### Sterling Ranch Sketch Plan 2023 Amendment & Rezone Traffic Technical Memorandum (LSC #S224441) September 28, 2023

### V1\_ TIS.pdf Markup Summary

Author: Jeff Rice - EPC Engineering Review

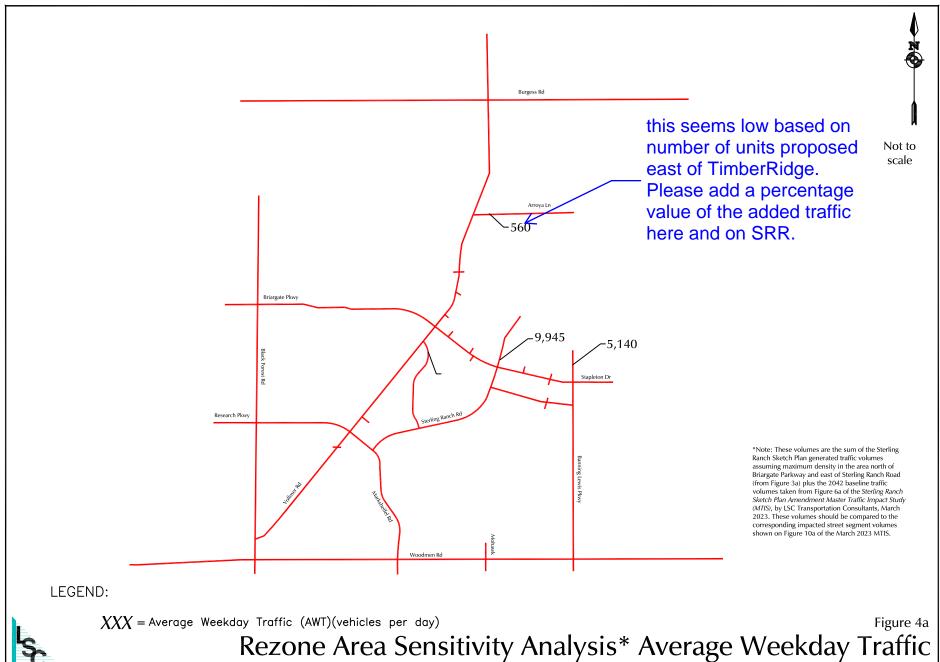
Status: Color: Layer: Space: show connection on all figures

Status: Color: Layer: Space: this seems low based on number of units proposed east of TimberRidge. Please add a percentage value of the added traffic here and on SRR.

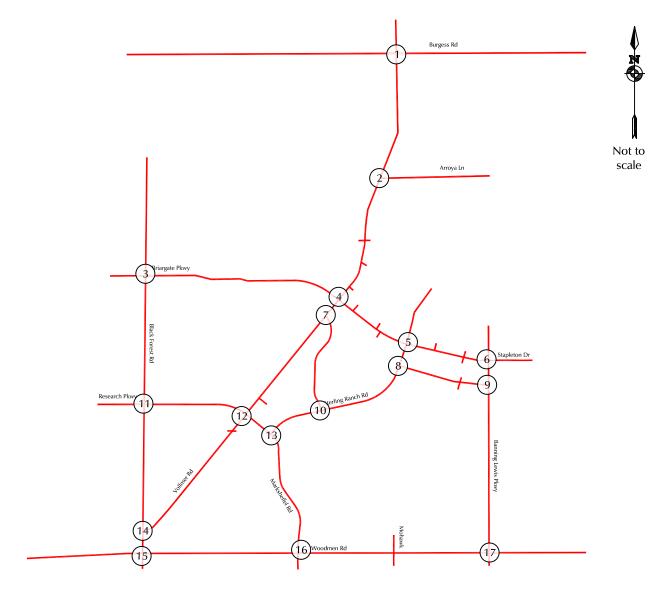
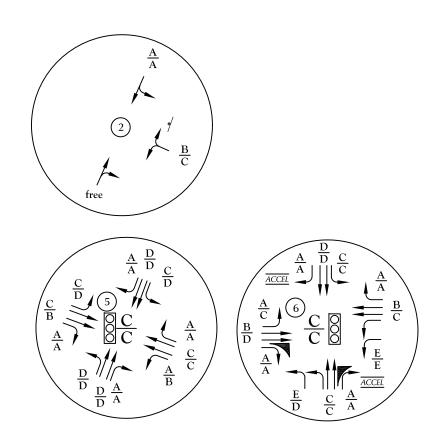
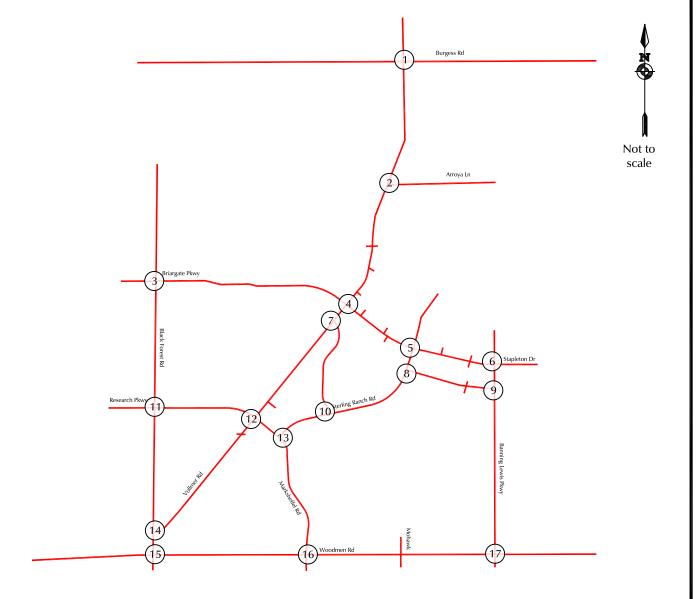
Status: Color: Layer: Space: this seems low based on number of units proposed east of TimberRidge. Please add a percentage value of the added traffic here and on SRR.

Rezone Area Sensitivity Analysis\* Lane Geometry, Traffic Control, and Level of Service

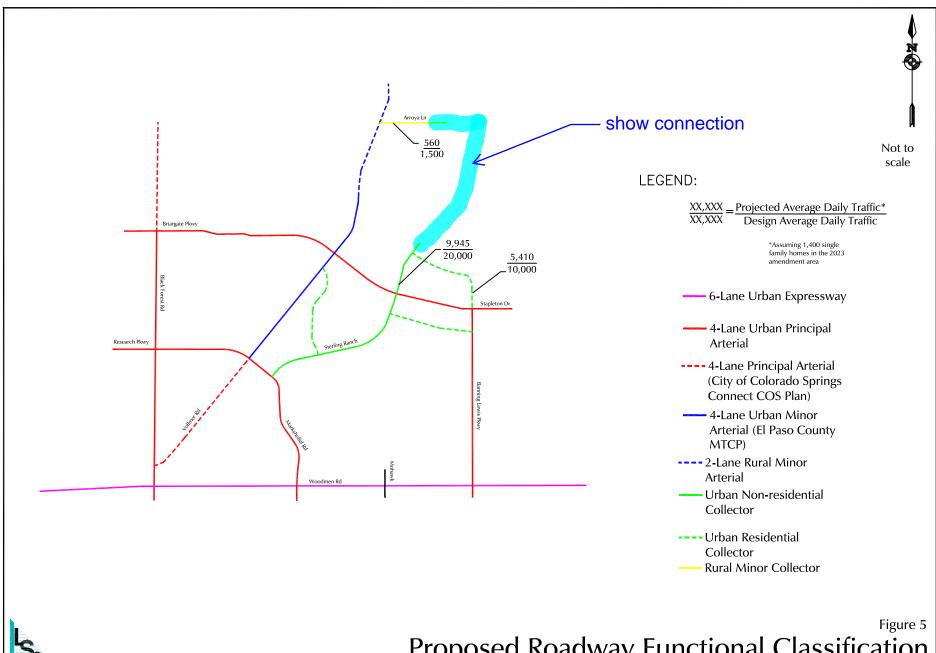
Status: Color: Layer: Space: show connection
